Mayfair Replat 5

RECOMMENDATION REPORT

CASE NUMBER: 2012-SUB-01

RE: Revised Application for Replat-Initial Review
Mayfair 2nd Addition Replat Five

JOB NO.	MAYFAIR 2nd ADDITION REPLAT FIVE	
06165.004	SARPY COUNTY, NEBRASKA.	
SHEET	1-1	
1 OF 1	FINAL PLAT

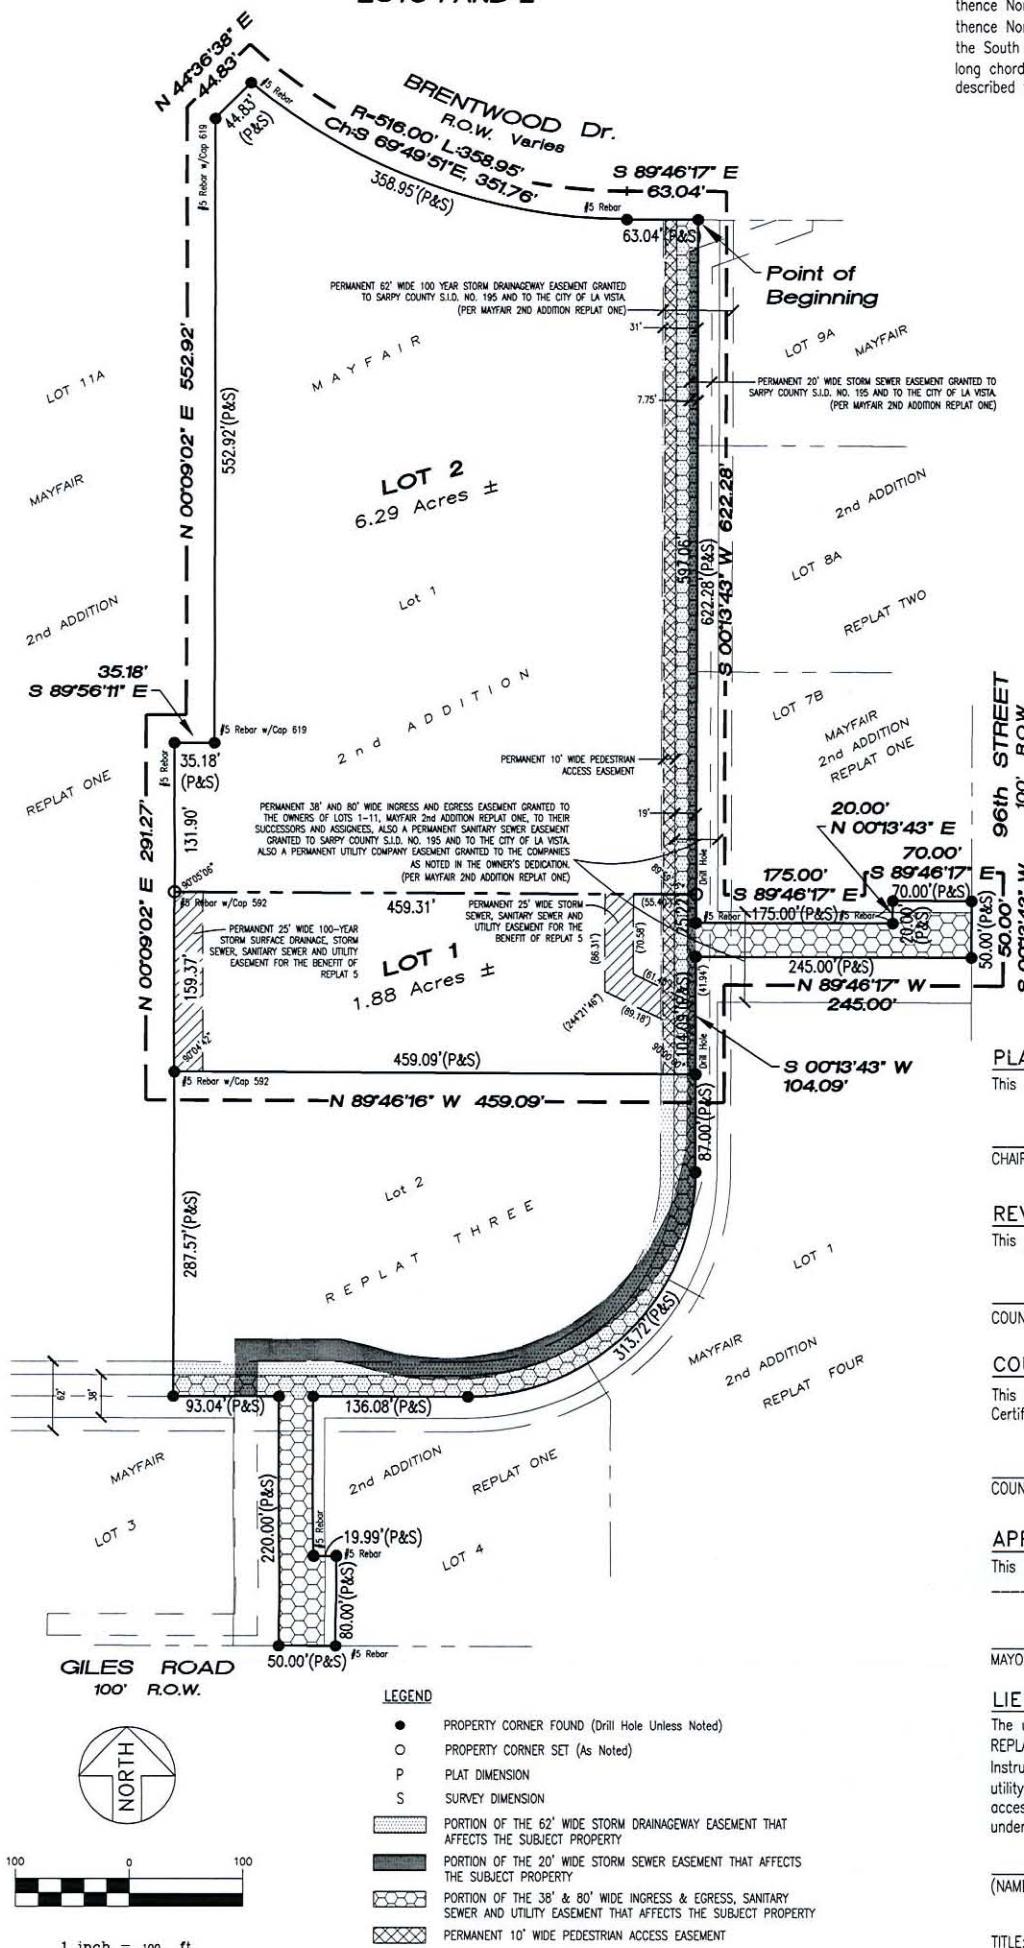
10. The final plat needs to address provision of easement rights for utility companies to serve the lots by notation or illustration or addition of language to the dedication.

11. The adjacent subdivision names to the west, north and east of the property need to be added.
12. Include an illustration and grant of a pedestrian easement for a sidewalk along the private roadway on the east end of Lots 1 and 2.

18. Revise the layout of the final plat drawing to provide a 5 inch by 2 1/2 inch blank space in the upper right corner to allow the Sarpy Register of Deeds a space in which to affix their recording stamp.

XHIBIT "PP-1"

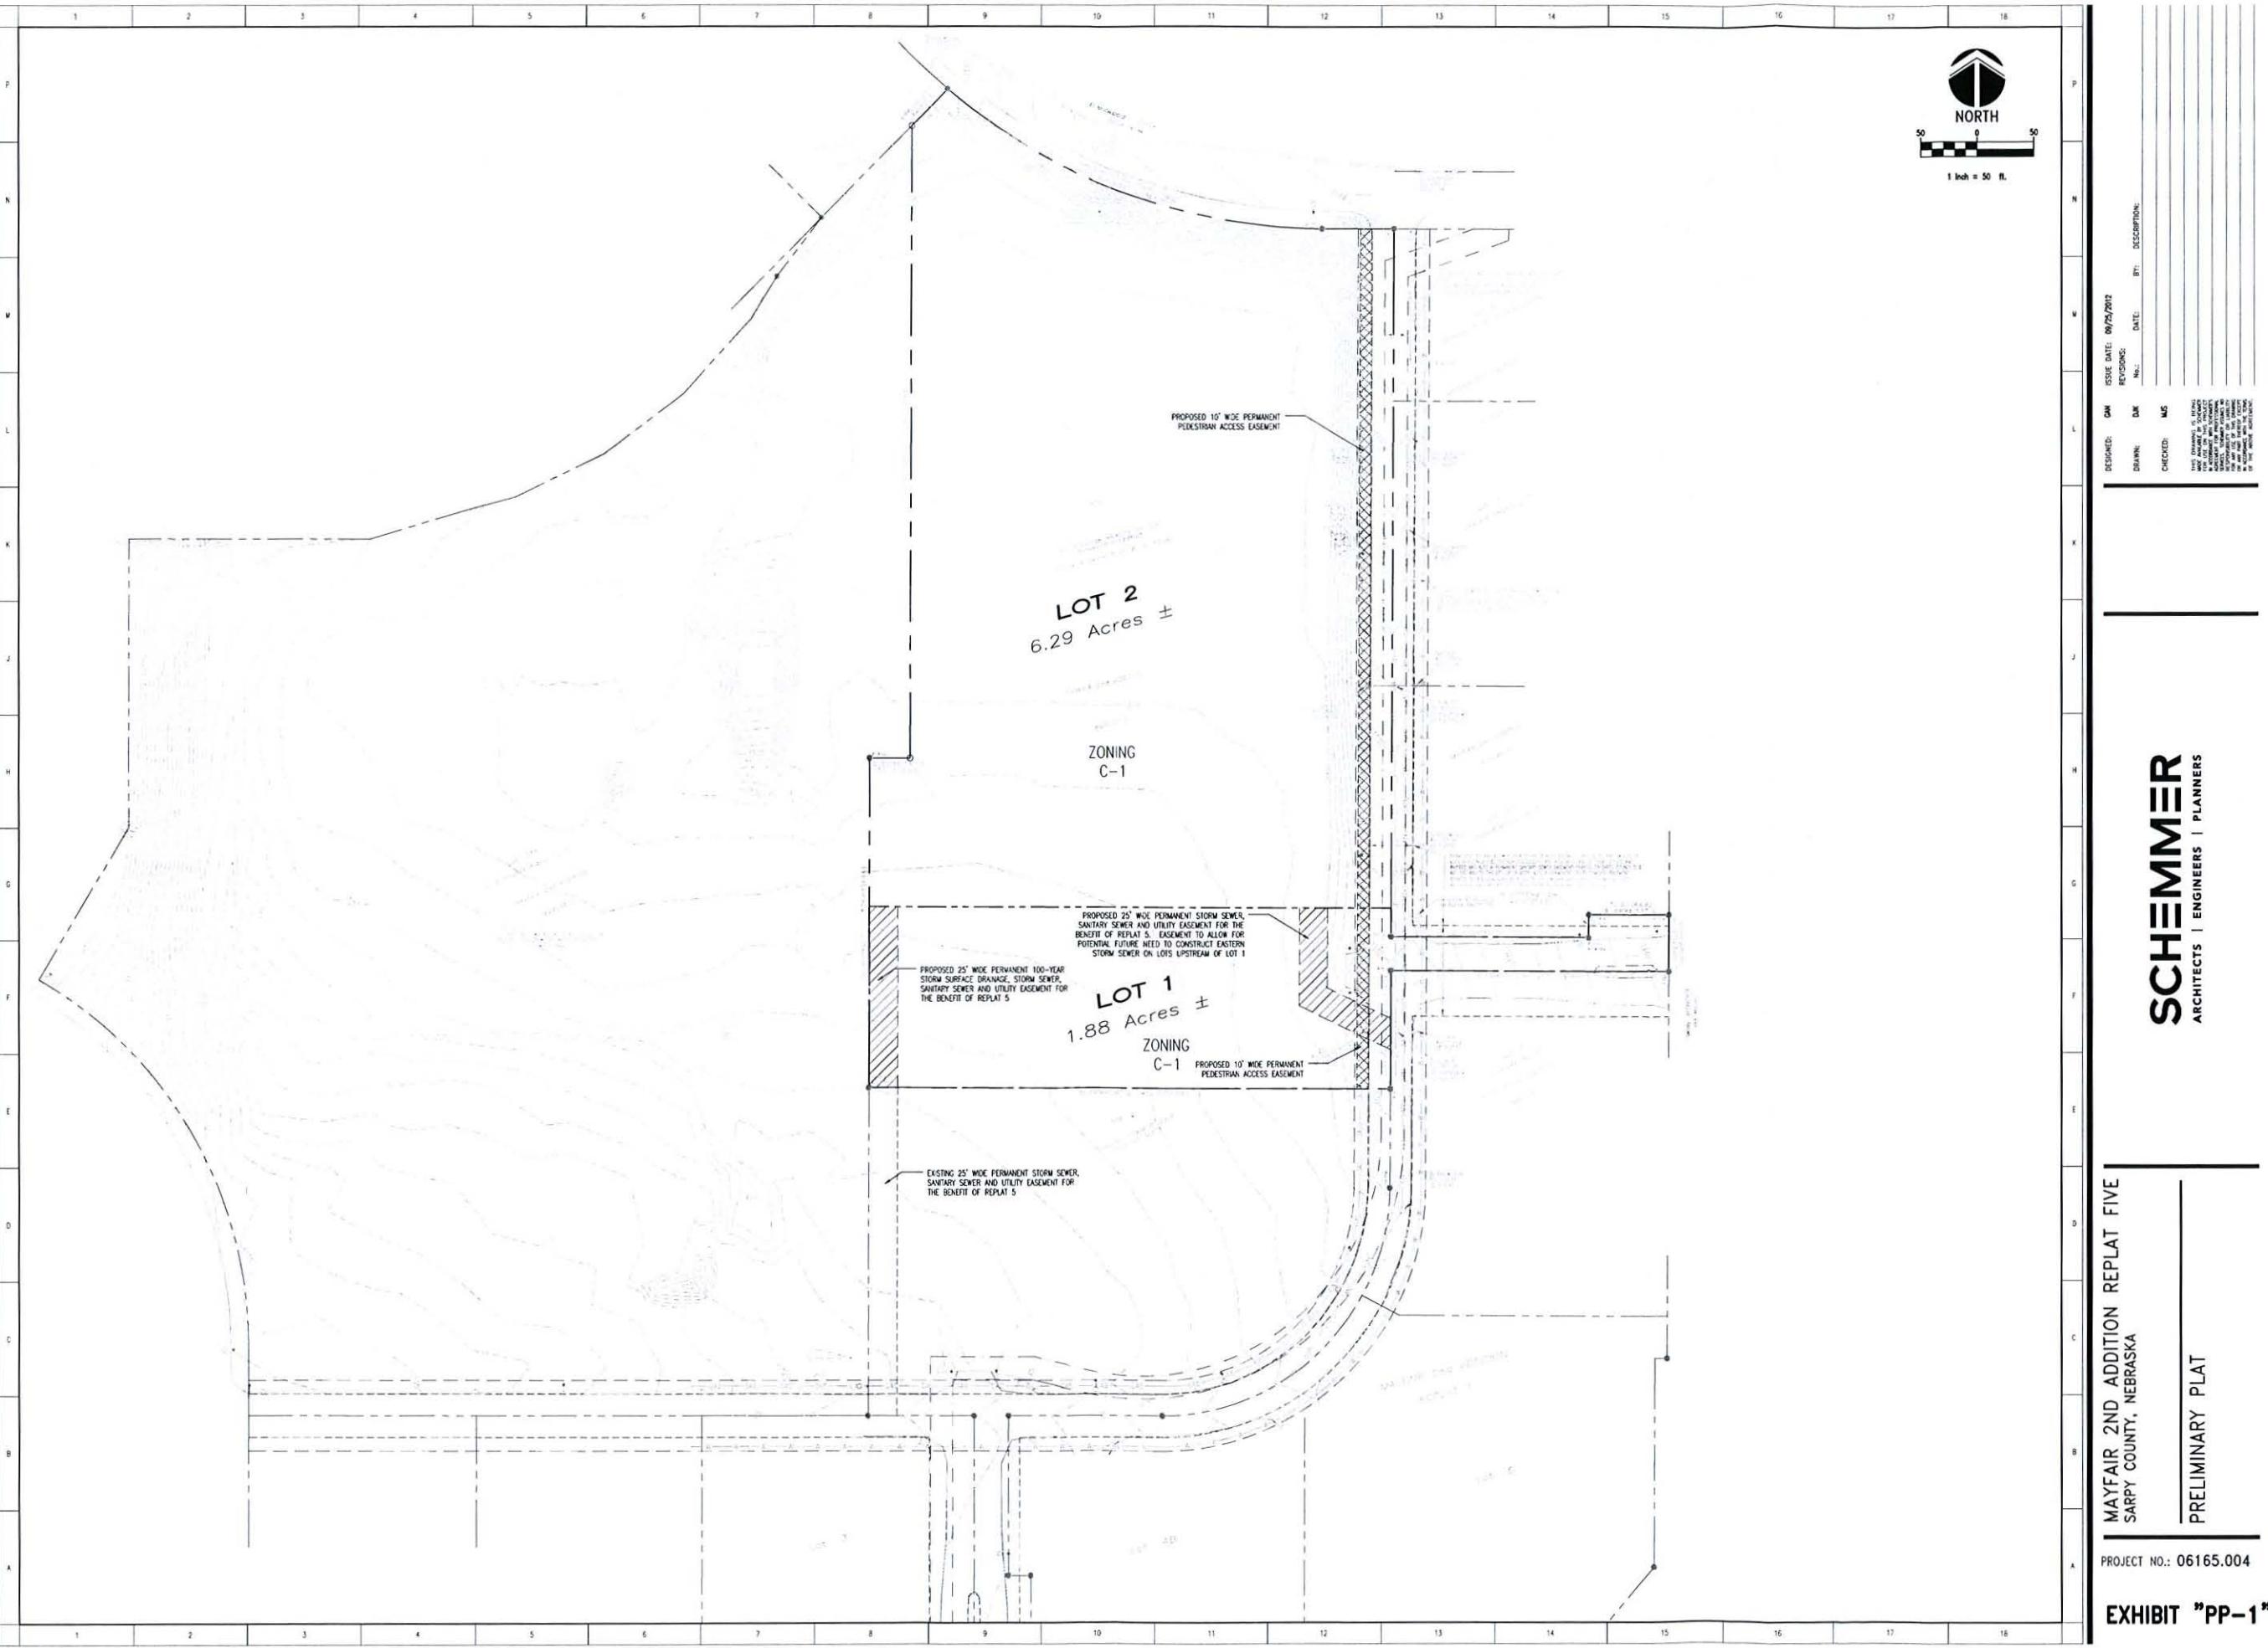
9. There is a proposed 25 feet wide “permanent storm sewer, sanitary sewer, and utility easement for the benefit of Replat 5” shown on the easterly end of proposed Lot 1 on Exhibit “PP-1”. Since Exhibit “B” notes each lot getting its own sanitary sewer service and a shared storm sewer will be built on the west end of Lot 1, an explanation as to the need for this easement should be provided.

EXHIBIT "B"

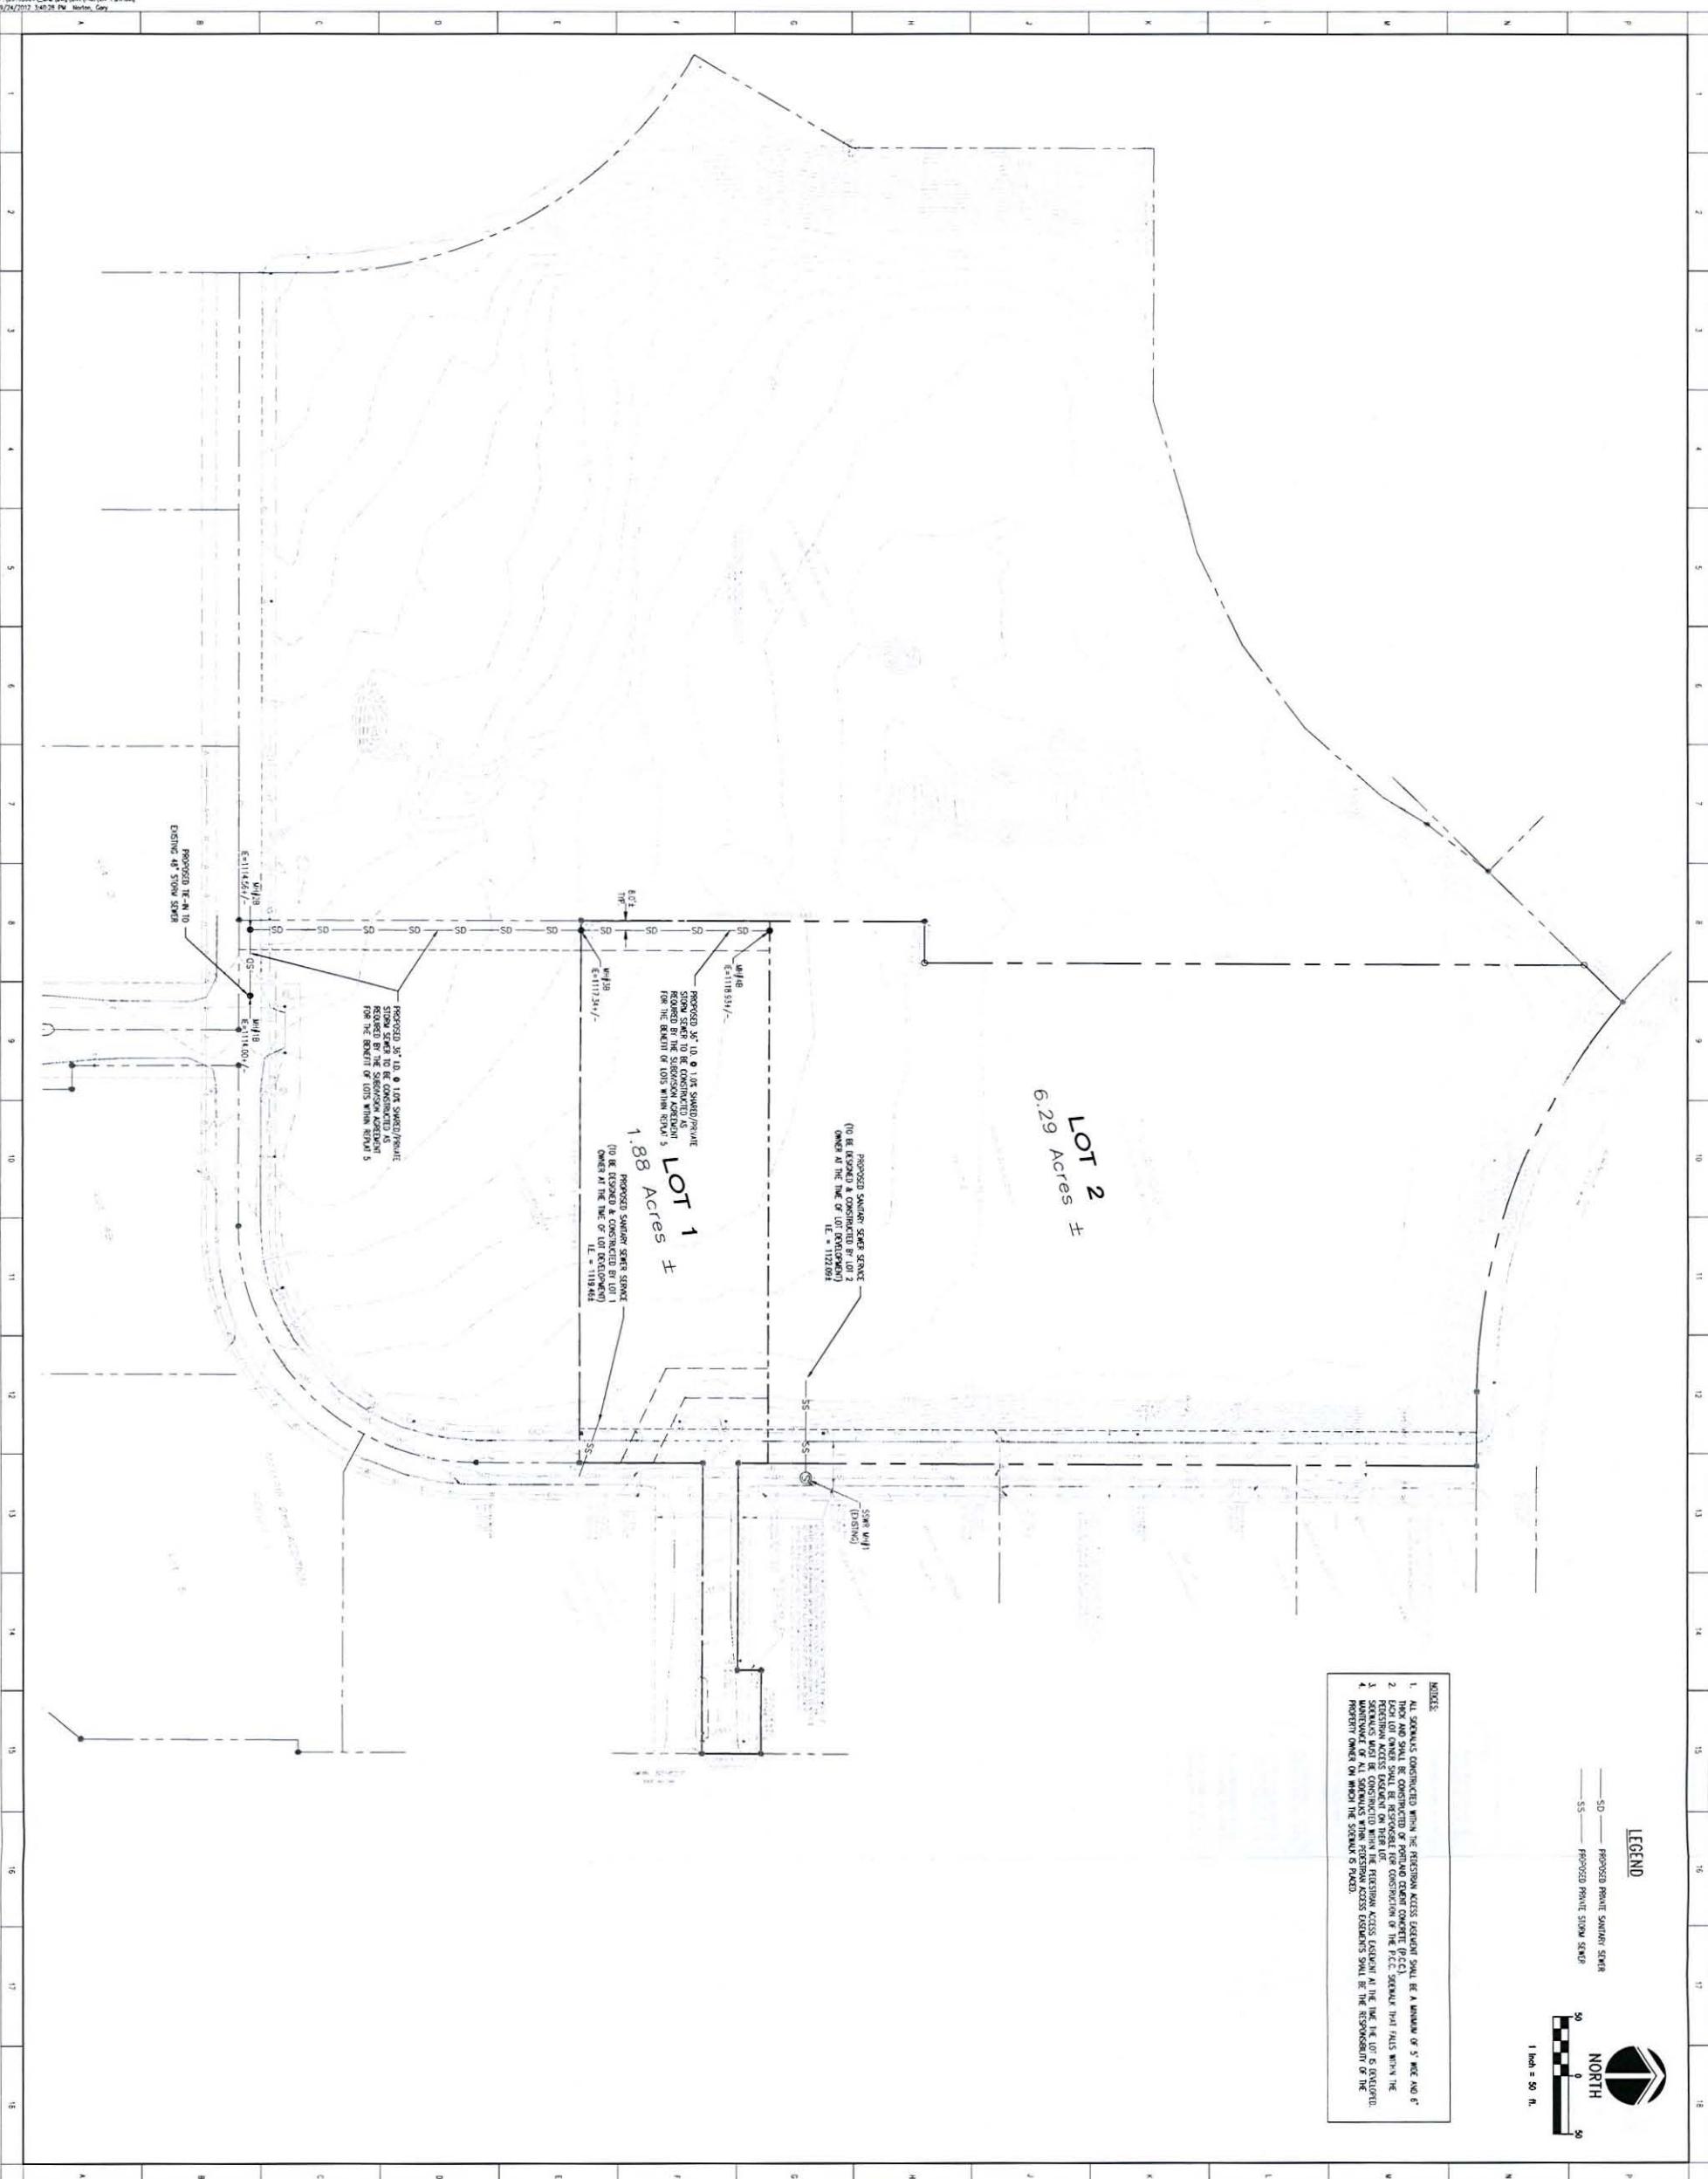
6. A storm water drainage study needs to be provided as part of the preliminary plat submittal. This will be a limited study to illustrate the drainage areas and assumptions made for the proposed 36-inch storm sewer noted on Exhibit "B".
